# **Mobile Pentium® II Processor Specification Update**

Release Date: June 1999

Order Number: 243887-011

Old Mobile Pentium® II Processor in Mini-Cartridge Package Label with Supplier Matrix Mark

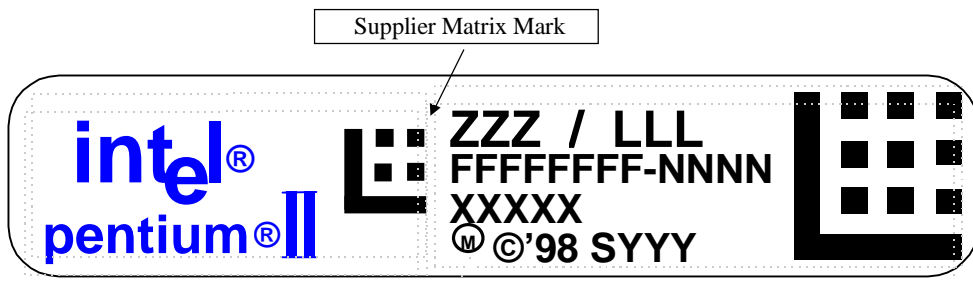
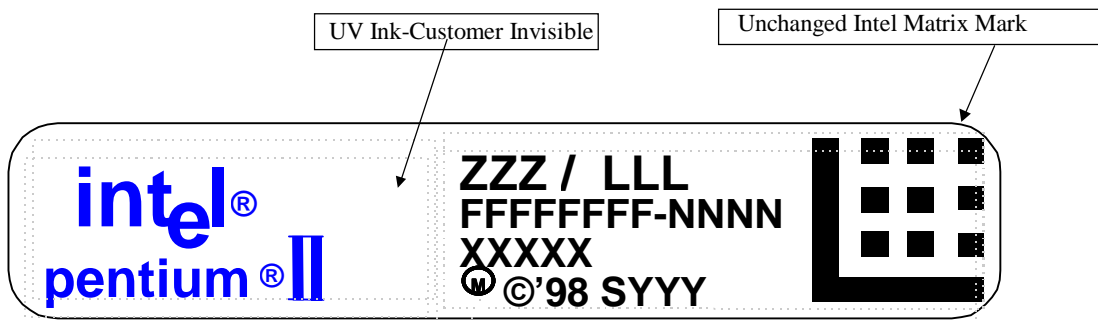
New Mobile Pentium® II Processor in Mini-Cartridge Package Label with Supplier Matrix Mark Removed

Figure 2. Workaround Flowchart: SMBALERT#-Driven System

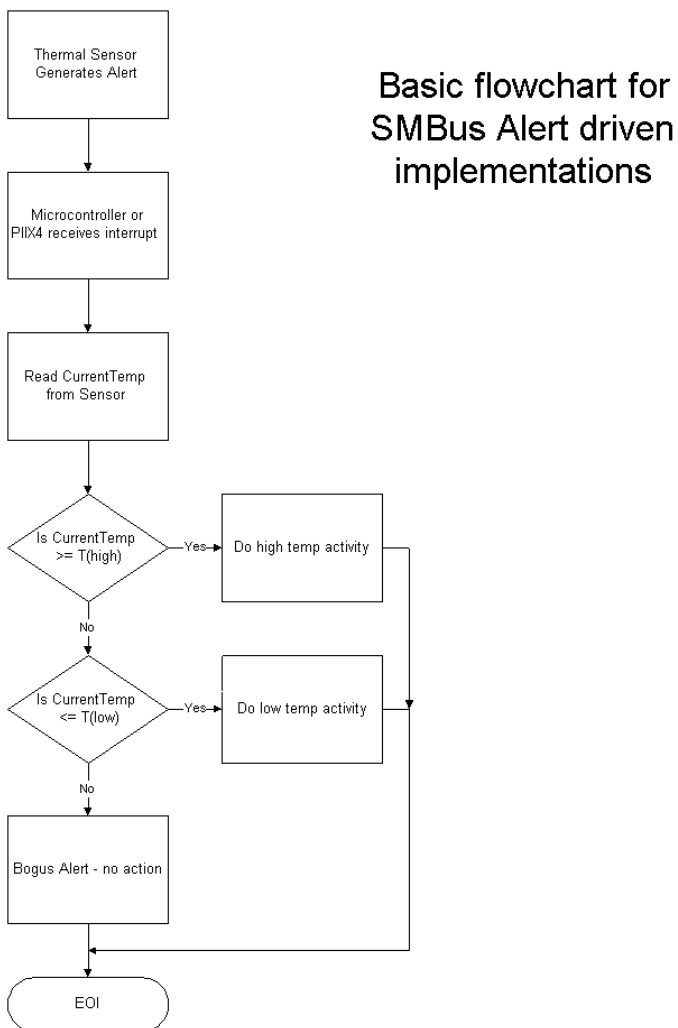
## **B30. Thermal Sensor May Assert SMBALERT# Incorrectly**

Under the conditions described below, the thermal sensor incorrectly generates the SMBALERT# interrupt. *All* of the following conditions must be met to trigger a false interrupt:

**WORKAROUND:** Three different (mutually exclusive) workarounds are possible:

1. Before servicing an interrupt from the thermal sensor, read and compare the processor thermal reading with the threshold limits ( $T_{HIGH}$  or  $T_{LOW}$ ). Figures 2 and 3 provide basic flowcharts for the implementation of this workaround in an interrupt driven system.
2. If the firmware implemented polls the Status Register only, then before taking any action, re-read the temperature register and do a comparison with the alarm threshold limits ( $T_{HIGH}$  or  $T_{LOW}$ ) to determine if the value is actually still within the temperature window.
3. Use a temperature polling scheme to monitor the processor temperature.

Figure 5.6. Cross Sectional View with Vertical Dimensions

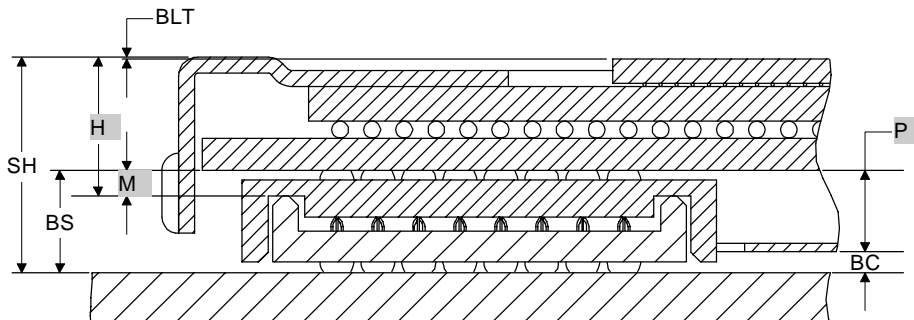
### B1. Misabeled Vertical Dimension Parameters

Figure 5.6 in the *Mobile Pentium® II Processor at 233 MHz, 266 MHz, and 300 MHz* datasheet should be replaced by the following figure:

**Figure 5.3. Surface-Mount BGA1 Package—Top and Side View**

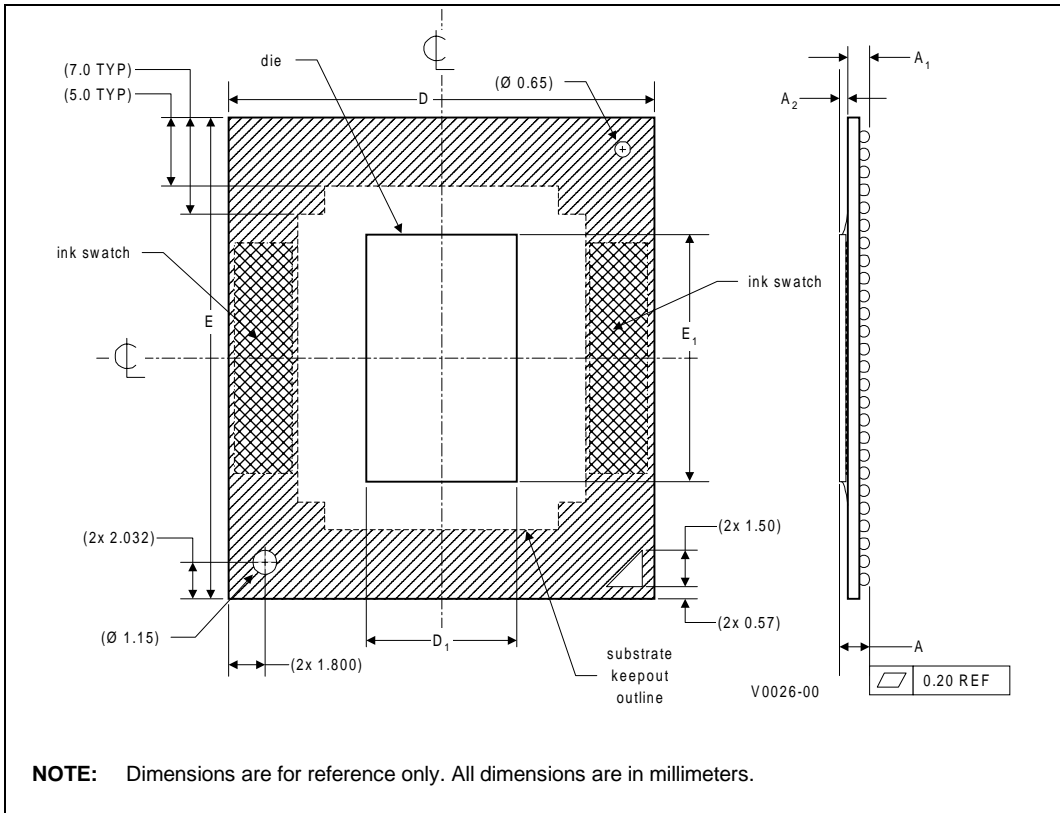
The following table and figures show the updated mechanical specifications for the BGA1 package, listed as Table 5.2, Figure 5.3 and Figure 5.4, respectively, in the *Mobile Pentium® II Processor in BGA Package at 366 MHz, 333 MHz, 300PE MHz, and 266PE MHz* datasheet.

Figure 1. TAP Gageable Thread Clarification

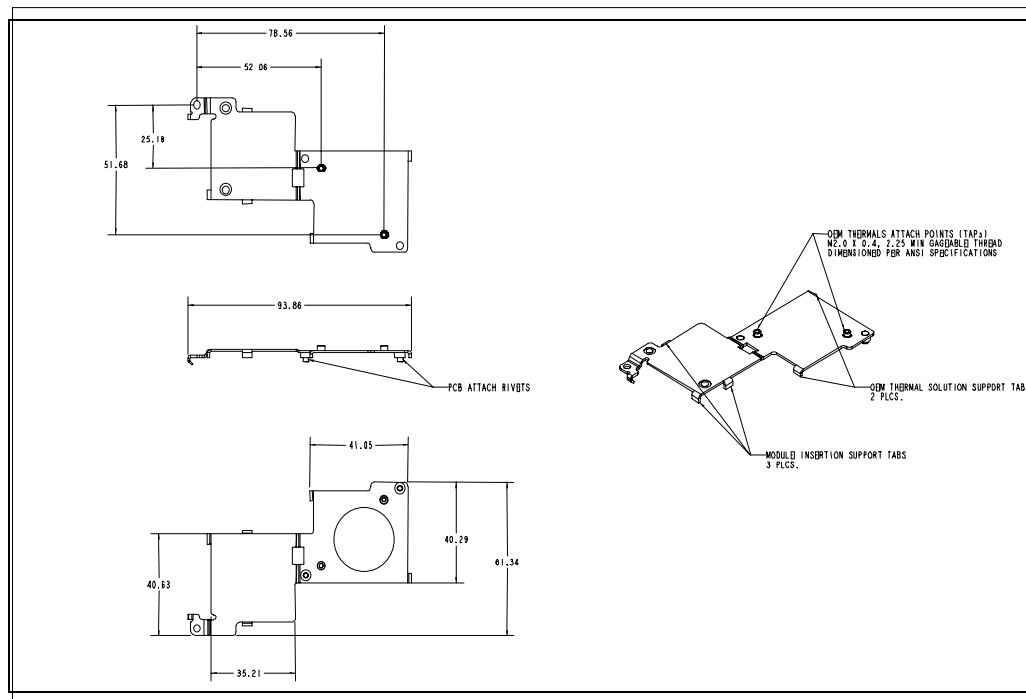
In the *Intel® Pentium® II Processor Mobile Module : Mobile Module Connector 1 (MMC-1)* and *Intel® Pentium® II Processor Mobile Module : Mobile Module Connector 2 (MMC-2)* datasheets (Order Numbers 243667 and 243668, respectively), the thermal attach point (TAP) gageable thread specification was not clearly identified in Figure 14, of Section 5.2. The following is the TAP clarification:

OEM Thermal Attach Points (TAPs) M2.0 x 0.4, 2.25 min gageable thread dimensioned per ANSI specification.

See Figure 1 below for more information.
